Application No. 10/596,727

Reply to the Office Action dated May 7, 2008

REMARKS/ARGUMENTS

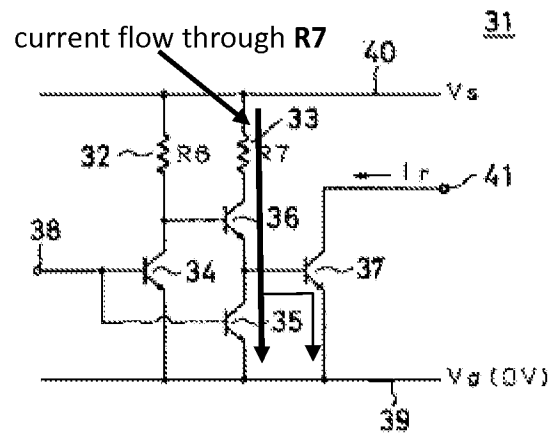
In response to Applicant’s argument that Taneji et al. fails to teach this feature, in the third paragraph on page 9 of the Office Action, the Examiner alleged that **R7** of Taneji et al. (which the Examiner alleged corresponds to the base current supply resistive element recited in Claim 7) is connected to **R6** of Taneji et al. (which the Examiner alleged corresponds to the current limitation resistive element recited in Claim 7) through **Vs**.

No current from **R7** of Taneji et al. flows through **R6** of Taneji et al. The current that flows through **R7** of Taneji et al. flows through reference numbers **35** and **36**, with some small portion flowing through **37**. As seen in the below marked-up **Fig. 5** of Taneji et al., the current through **R7** flows from v_s (source) to v_g (ground), without flowing through **R6**. Although both **R6** and **R7** are connected to v_s , none of the current that flows through either one flows through the other. **R6** of Taneji et al. does not limit the current from **R7** of Taneji et al. That is, Taneji et al. fails to teach or suggest the feature of “a current limitation resistive element ... that limits the current of the base current supply resistive element that turning ON of the ground side current bypass transistor allows to flow” as recited in Claim 7.
